**ON-SITE SEWAGE DISPOSAL SYSTEM  
HOWARD COUNTY HEALTH DEPARTMENT  
BUREAU OF ENVIRONMENTAL HEALTH**

SUBDIVISION: Hinzman LOT NUMBER: 1

ADDRESS: 818 Hoods Mill Road PROPERTY OWNER: Dorsey Family Homes

WALL CHECK  
LOT 1  
SITUATED ON MD. RT. 97  
HINZMAN PROPERTY  
ELECTION DISTRICT NO 4  
HOWARD COUNTY, MD.  
SCALE: 1" = 100' MAY, 2001

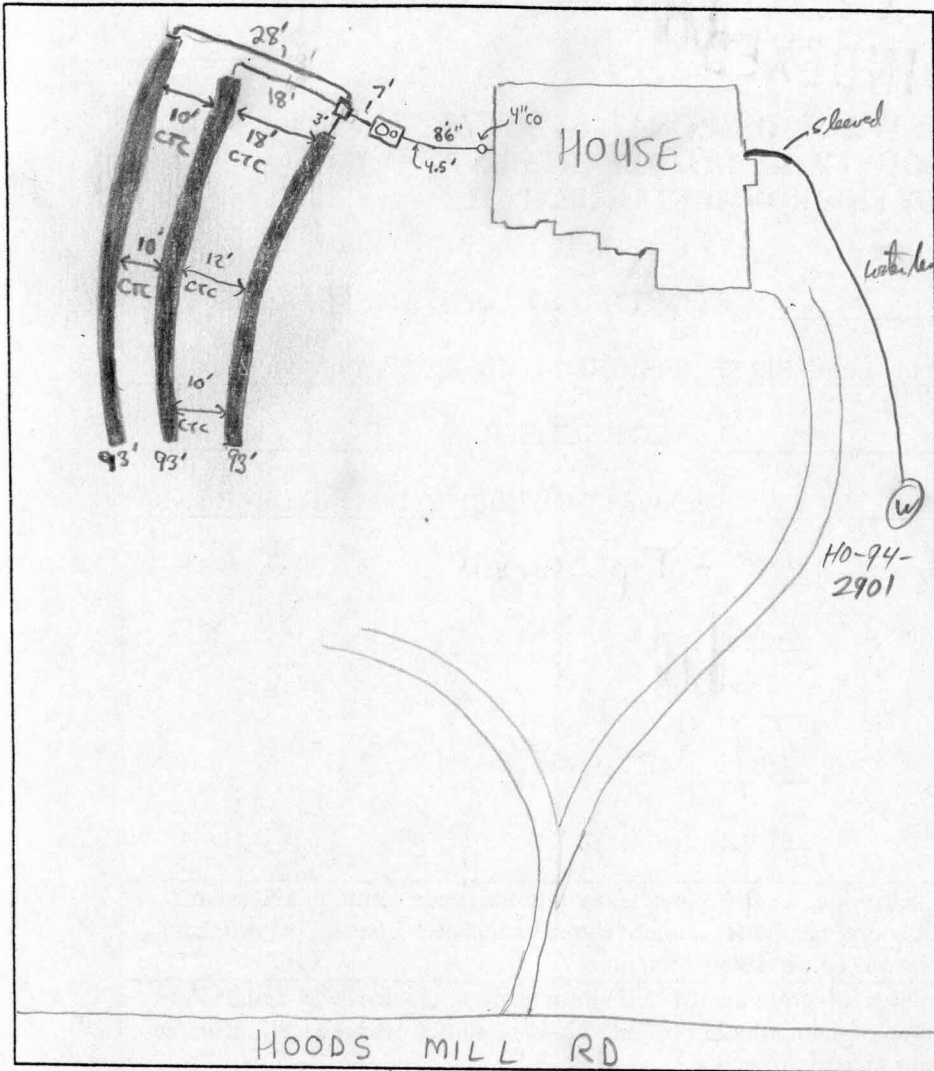
INSPECTION COMMENTS: 7/5/01 - OK TO CONTINUE WORK, LAST TRENCH TO BE 10' CTC - SRW  
7/6/01 - OK TO COVER ALL WORK, TRENCH → SPACING WIDER BETWEEN TRENCH  
① & ② (AT BEGINNING OF TRENCH) DUE TO CONTOUR, OK TO COVER ALL  
WORK - SRW

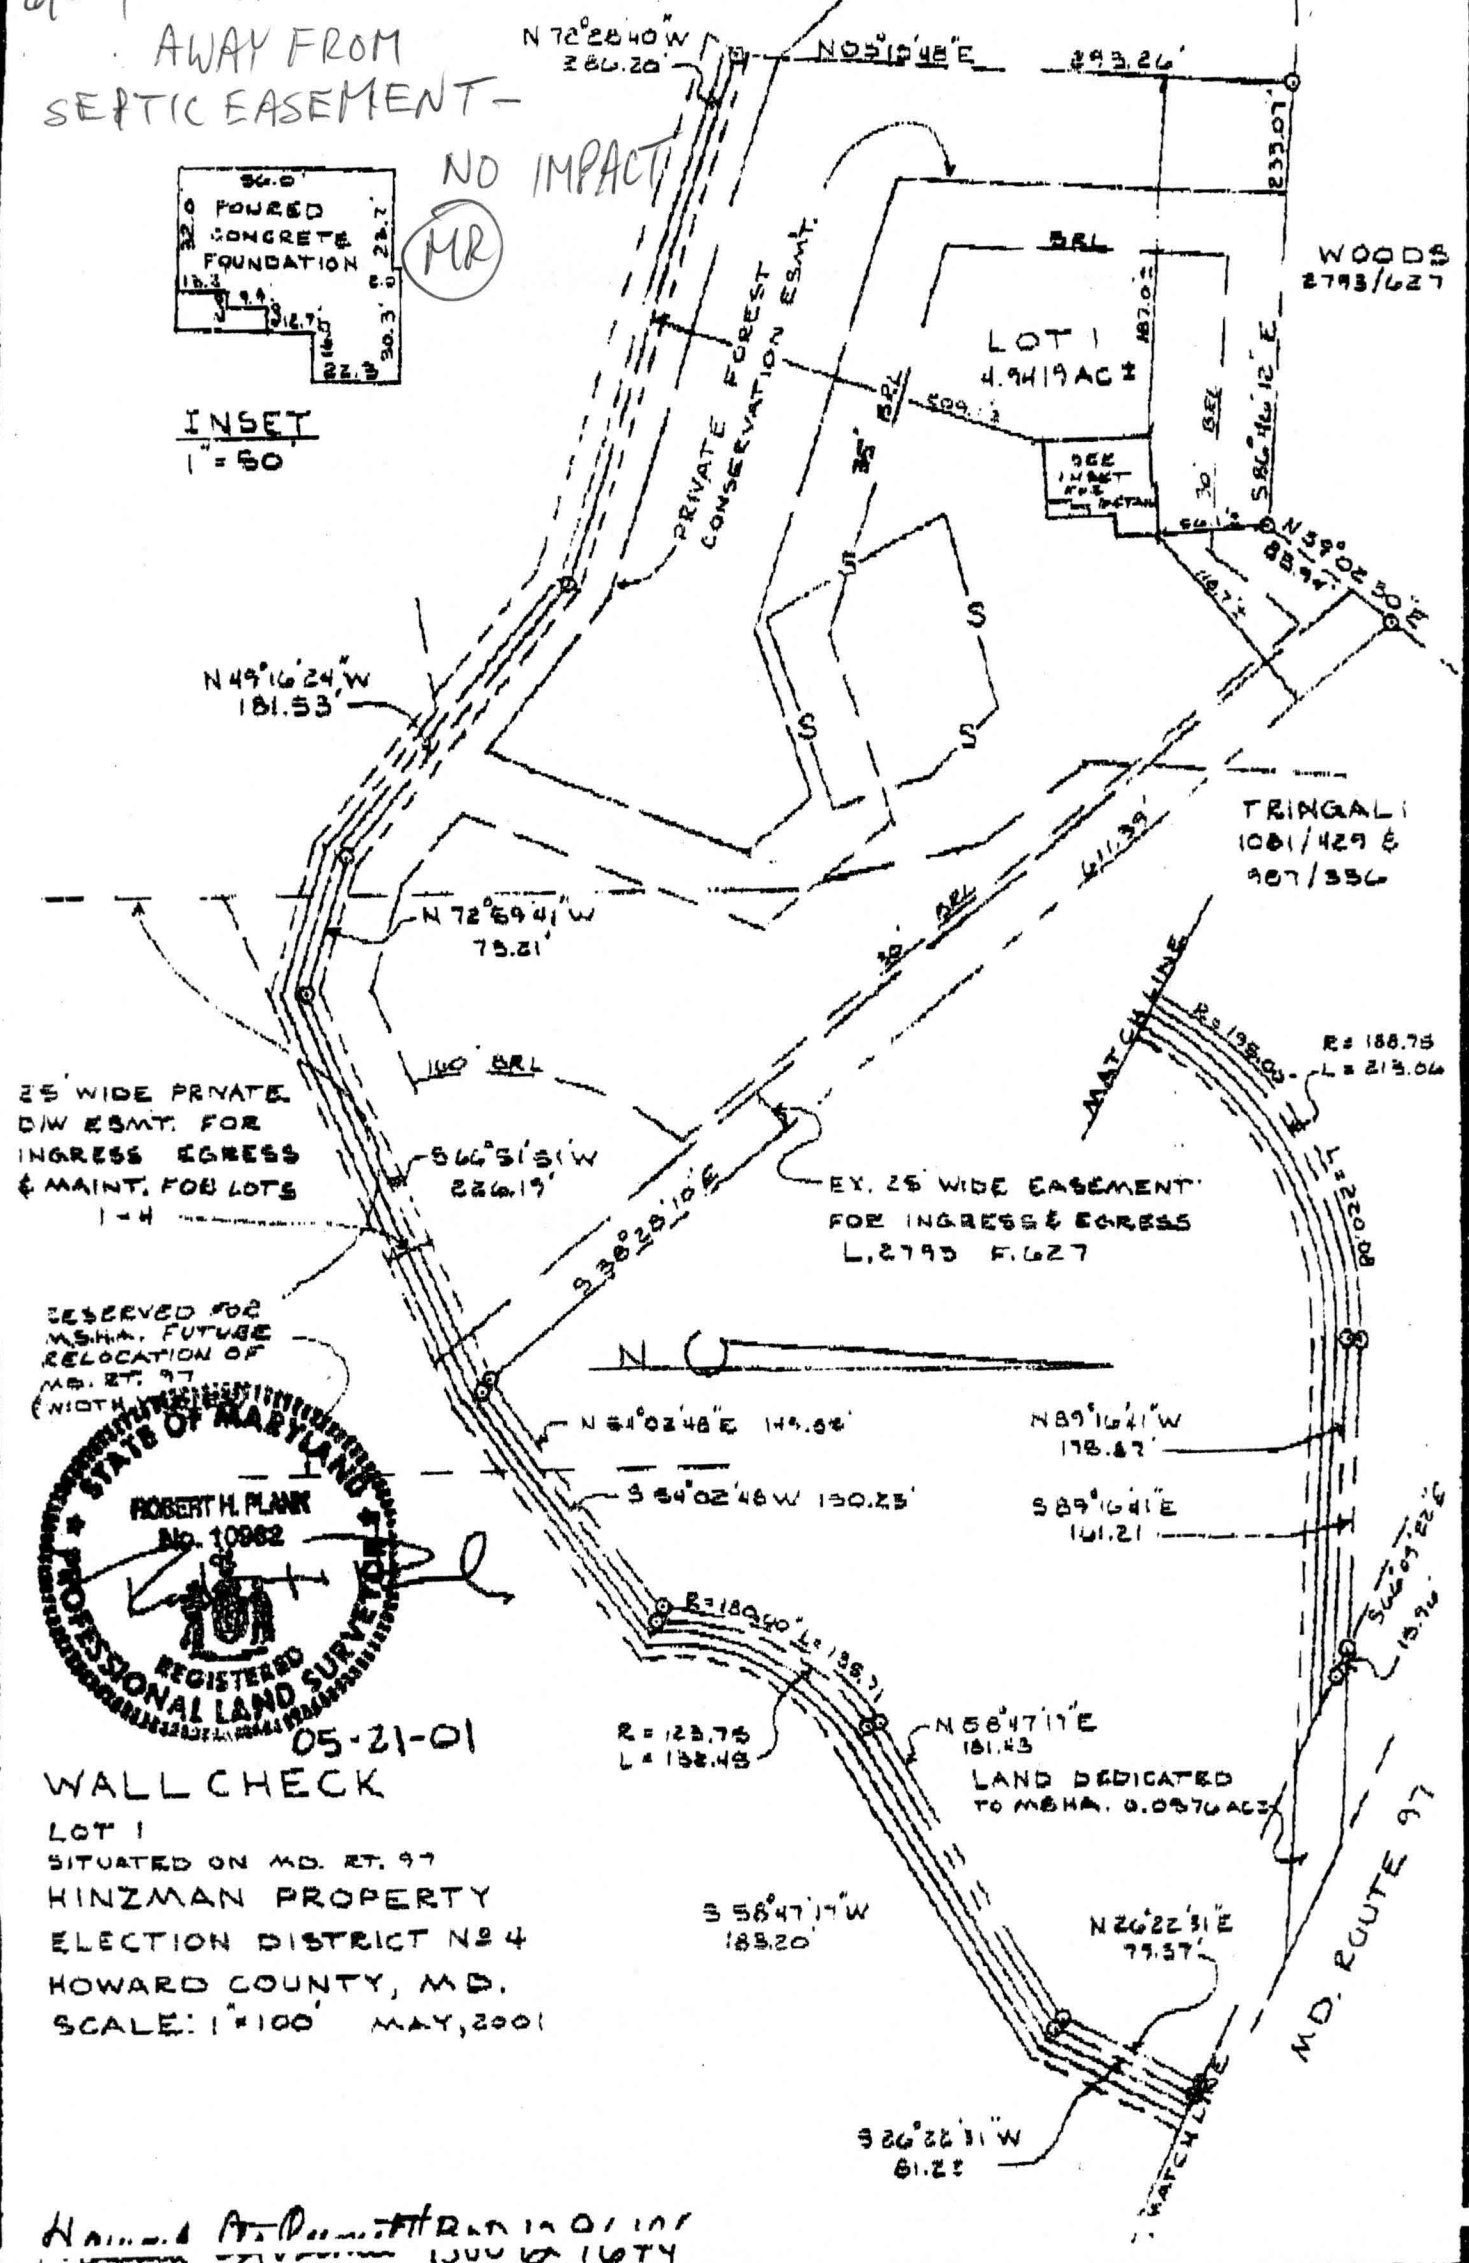
6/20/01 HOUSE ROTATED LOT 2

AWAY FROM SEPTIC EASEMENT -

NO IMPACT
